STANDARD STATE REPORT 41K

SYCAMORE STORE

7025 MACARTHUR BLVD
BETHESDA, MD 20816

Address:	7025 MacArthur Boulevard, Bethesda	Meeting Date:	2/27/08
Applicant:	Dean Brenneman	Report Date:	2/20/08
Resource:	<i>Master Plan Site #35/155</i> Sycamore Store	Public Notice:	2/13/08
Review:	HAWP	Tax Credit:	None
Case Number:	35/155-08A / REVISION 35/155-07A	Staff:	Anne Fothergill
Proposal:	Revisions to approved alterations

FRONT ELEVATION

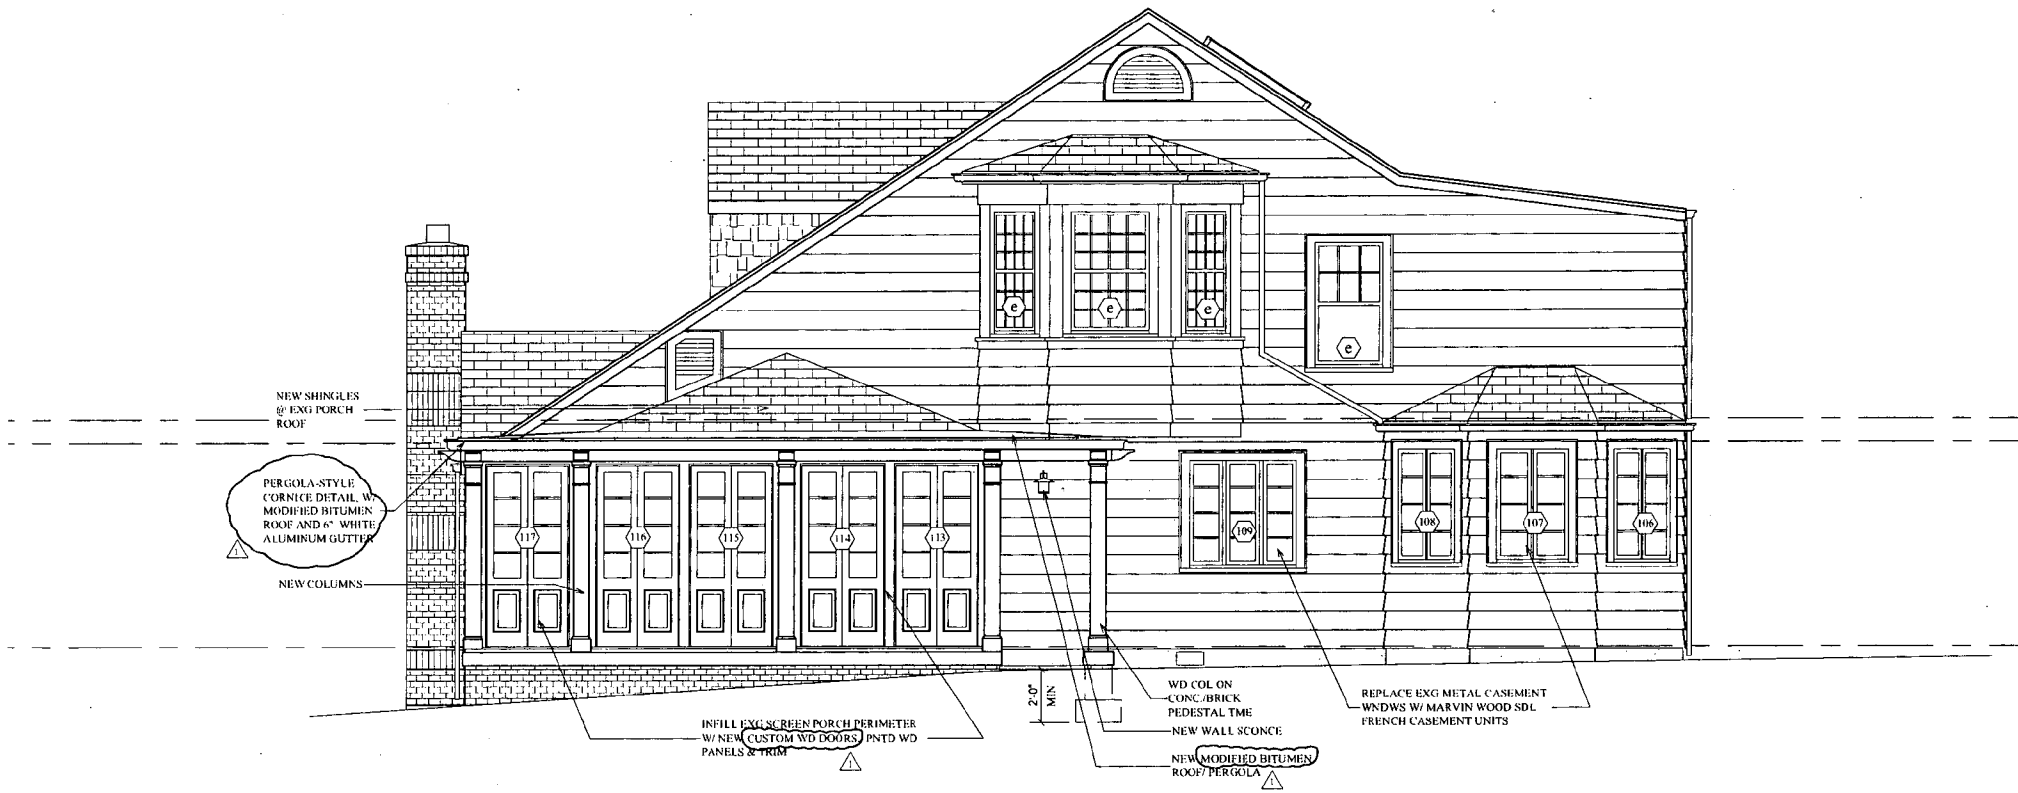
- Right side: Replace approved 10-lite windows with wood panels with 8-lite wood doors with larger wood panels below
- Front: Replace five vertical 5-lite windows and lower wood panels on the front elevation with three central wood panels and two 4-lite sidelights with panels below

The other change that concerned staff is the more visible change that is proposed on the front elevation where there is currently a screened porch. The HPC approved enclosing the screened porch and creating a sun room. The approved plan showed a lot of glazing to recall the screened porch, which was an open porch when built – the porch was not an original feature but added in the late 20s/early 30s. On the right side, the proposed doors still create a sunroom effect. But in the front, with the proposed center wood panels and sidelights, the idea of a glazed sun room to recall a porch is gone. Staff understands the applicant's desire to insulate from the noise from traffic on the busy road. Staff also recognizes that the porch was not an original feature of this house, and, as noted earlier, this building was designated for its importance in the Glen Echo Heights community, not for its specific architectural features. However, the front faces Macarthur Boulevard and is the primary elevation and this would be a large change to the most recognizable and visible façade of this building. Staff recommends that the applicant and staff work on a design solution for this section of the front elevation with more glazing so as to return to that initial porch intent. Staff also recommends that the final design will be reviewed and approved at the staff level.

2. **Eliminate three sections of glass panels on the front of the screened porch enclosure.** I am finding that the busy traffic on MacArthur presents a problem for a "mostly glass" office. I would like to shield this view and provide a bit of privacy. I also like the quirky nature of it.

1. The applicant will revise the plans for the front and right side elevations of the screened porch enclosure to show additional glazing. Final design to be reviewed and approved at the staff level.

1. The applicant will revise the plans for the front elevation of the screened porch enclosure to show additional glazing. Final design to reviewed and approved at the staff level.

Proposed right side

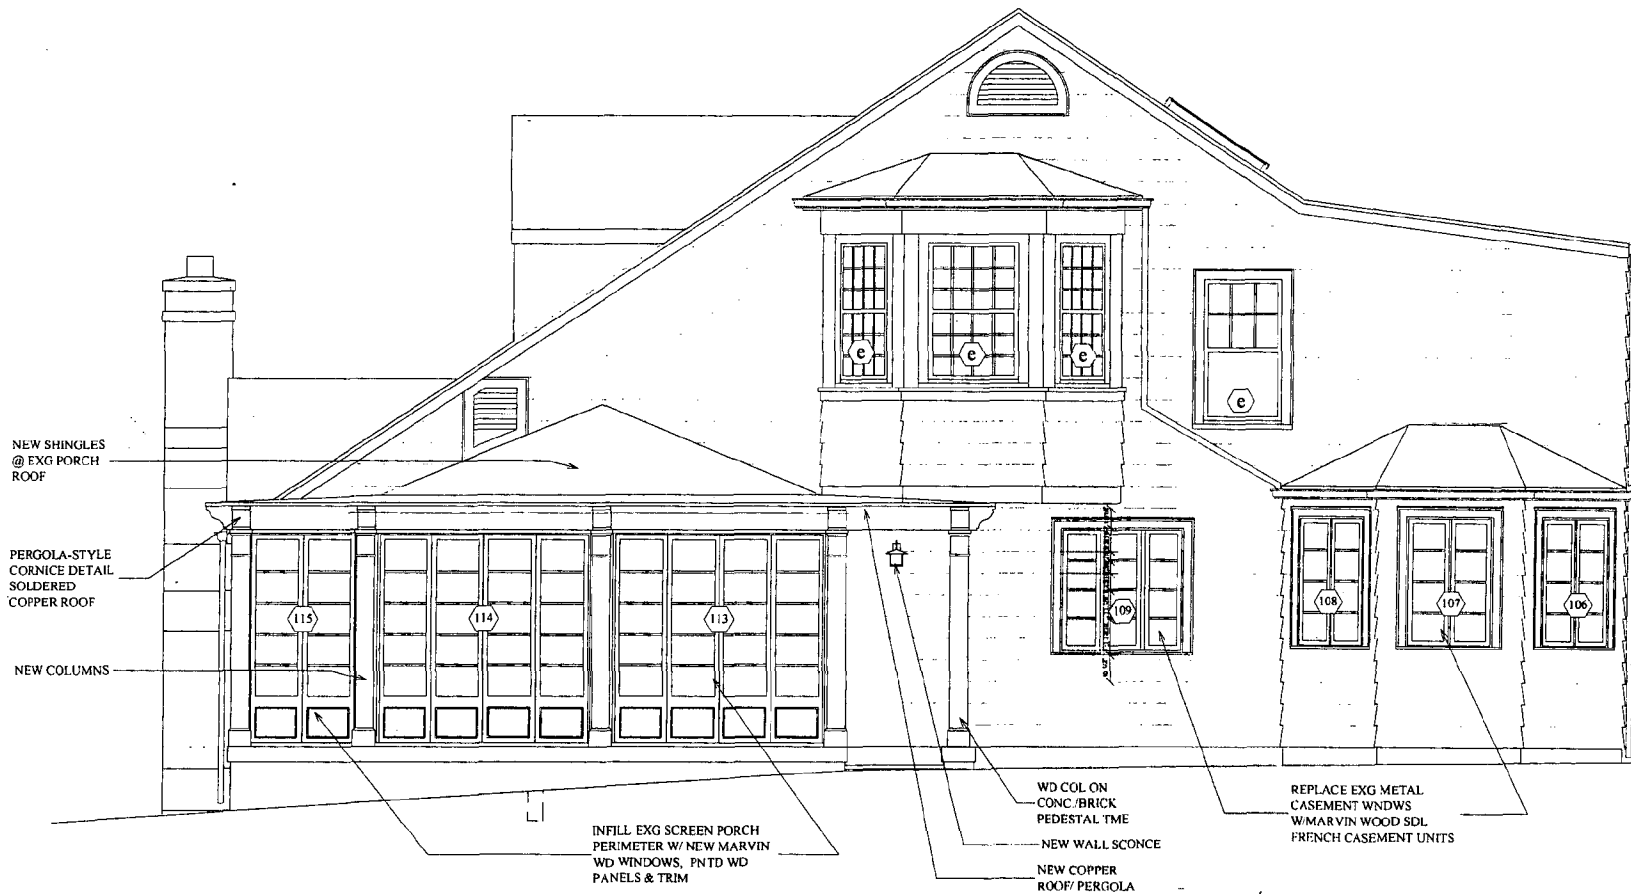
Most of these proposed changes to the HPC-approved plans are minor and barely visible and will have minimal or no impact on the historic resource. One change that staff had some concern about was the new window opening on the right elevation, which is not something that the Commission generally supports. However, the building was designated for its importance as a commercial icon in the community, not for its specific architectural features, and staff supports the reuse of an original window on the side elevation of the building as it will not impact the massing or the character of the building.

3. **Add one window on the North Façade (relocated from the South façade at the old porch).** You will see that our landscaping plan makes this window very unobtrusive. We want to get daylight into the adjacent office space, as I feel strongly about giving all employees access to natural daylight. The window will be salvaged from elsewhere in the building.

Proposed Rear

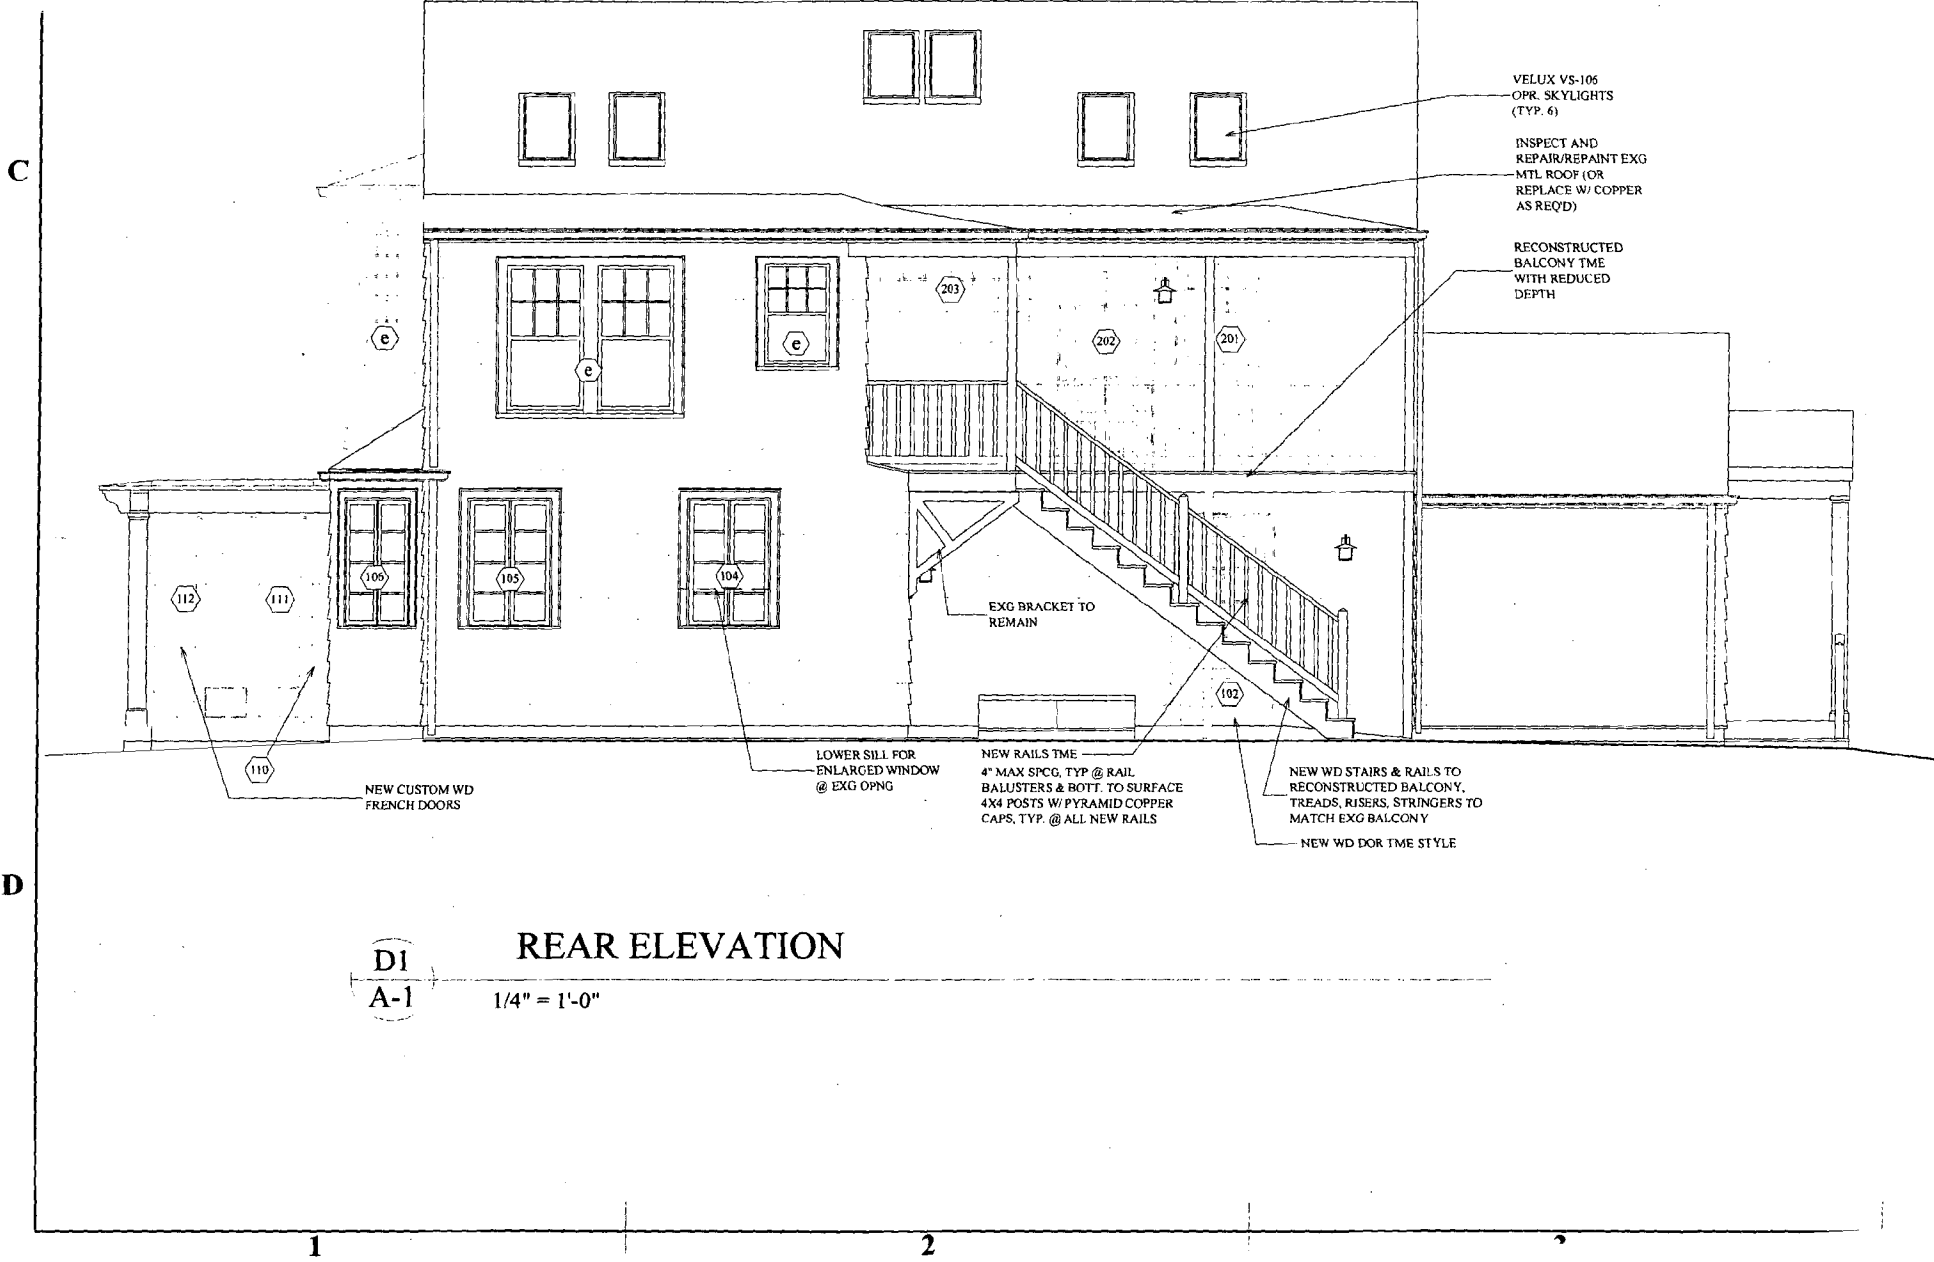
- Reuse original window (approved to be removed from right side) in new window opening on first floor
- Retain existing 2nd floor door where replacement window was approved
- Replace existing 1st floor door with wood window

6. **Replace house numbers.** A minor item, but we thought we should bring it to your attention.
7. **Don't replace door (@ upper level of rear porch) with a window.** Instead replace the door below it with a window. This lower door does not meet building code requirements for a landing space outside and also has a head-height that is obstructed by the bracket for the porch above.
